UNITED STATES PATENT AND TRADEMARK OFFICE

| APPLICATION NO. | FILING DATE | FIRST NAMED INVENTOR | ATTORNEY DOCKET NO. | CONFIRMATION NO. |
|--|-------------|----------------------|---------------------|------------------|
| 09/869,784 | 10/16/2001 | Toshiyasu Ito | 04208.0112 | 8751 |

| Office Action Summary | Application No. 09/869,784 | Applicant(s) ITO ET AL. | |

DETAILED ACTION

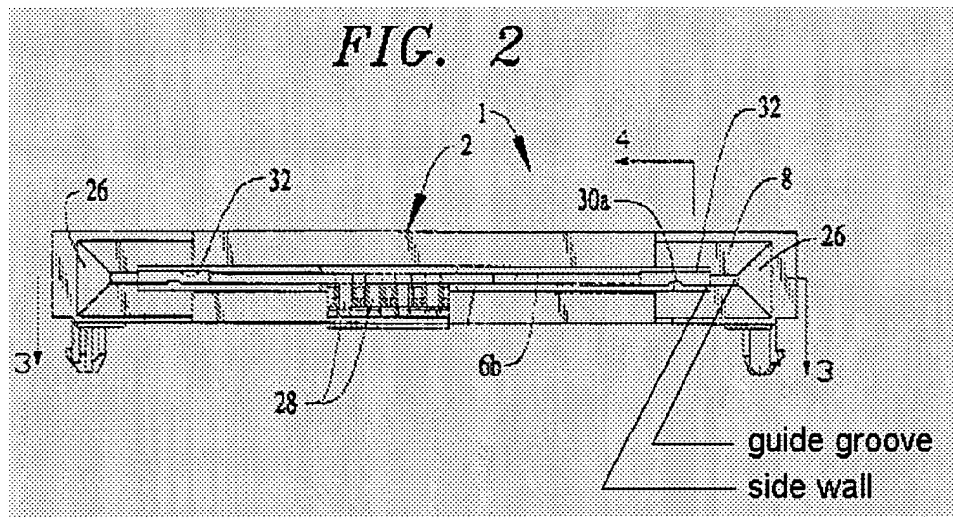
Asakawa discloses a card connector comprising: a pair of guide grooves (see following figure) formed on both sidewalls of a connector housing (2); and sidewalls (see following fig.) to define, below a space between the pair of guide grooves, and a base plate with a plurality of contact terminals arranged in the base plate to couple with

contact of a bottom surface of a card. Asakawa also discloses a first space (between the sidewalls) and a second space (between the guide grooves).

Regarding claims 2, 12 and 22, Asakawa discloses the sidewalls formed at such locations that they can guide the side surfaces of a lower body portion of a first card (C).

Regarding claims 5, 6, 15, 25 and 26 Asakawa discloses a housing top plate that forms upper walls of the guide grooves is formed with an opening / a recess (adjacent 12) having a width larger than a lower body portion of a first card, i.e. a least the same size as the separation between the side walls.
